Access Compliance Report

Public Rights-of-Way

Intersection ID: 12779	Main Street: E_TRADE_ST	Cross Street: S_DAVIDSON_ST	Location: W
ADA ID: 3C4C1A6E09B7	Ramp Type: Perp	Initial Pass/Fail: Fail	Overall Compliance: No
			Severity Score: 13.75

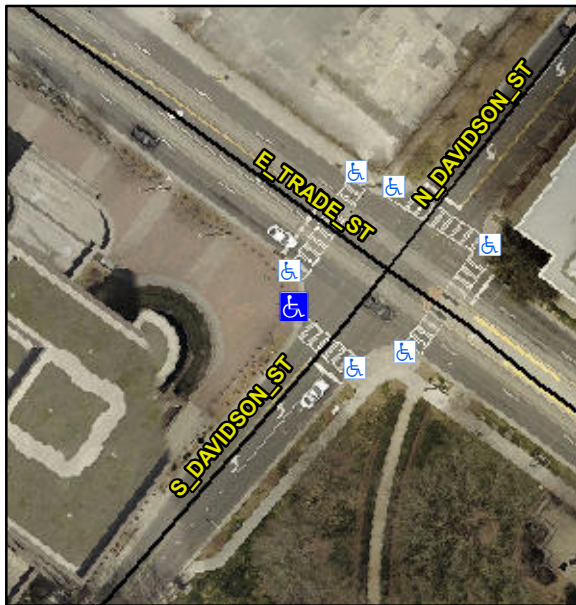
Not Found, R304.2.2

Compliance	Description	Data	Compliance	Description	Data
N/A	Ramp Length (in)	70.0	No	Ramp Slope (%)	9.1
Yes	Ramp Width (in)	48.0	Yes	Ramp XSlope (%)	2.1
N/A	Flare Type LT	N/A	N/A	Flare Type RT	N/A
N/A	Flare Slope LT (%)	N/A	N/A	Flare Slope RT (%)	N/A
N/A	Flare Traversable LT?	N/A	N/A	Flare Traversable RT?	N/A
N/A	Landing Length (in)	N/A	N/A	DWS Provided?	N/A
N/A	Landing Width (in)	N/A	N/A	DWS Contrast?	N/A
N/A	Landing Slope (%)	N/A	N/A	DWS Length (in)	N/A
N/A	Landing X Slope (%)	N/A	N/A	DWS Full Width?	N/A
N/A	Landing Curb? (Y/N)	N/A	N/A	DWS Offset (in)	N/A
N/A	Shared Landing?	N/A			
N/A	Gutter Ponding?	N/A	N/A	Gutter Slope (%)	N/A
N/A	Gutter Lip Ht (in)	N/A	N/A	Gutter X Slope (%)	N/A
N/A	Painted X Walk1?	Yes	N/A	Painted X Walk2?	N/A
	X Walk 1 Direction	To SE		X Walk 2 Direction	N/A
N/A	X Walk 1 Width (in)	118.0	N/A	X Walk 2 Width (in)	N/A
	X Walk 1 Slope (%)	2.5		X Walk 2 Slope (%)	N/A
	X Walk 1 X Slope (%)	2.1		X Walk 2 X Slope (%)	N/A

Remove & Replace Entire Ramp.
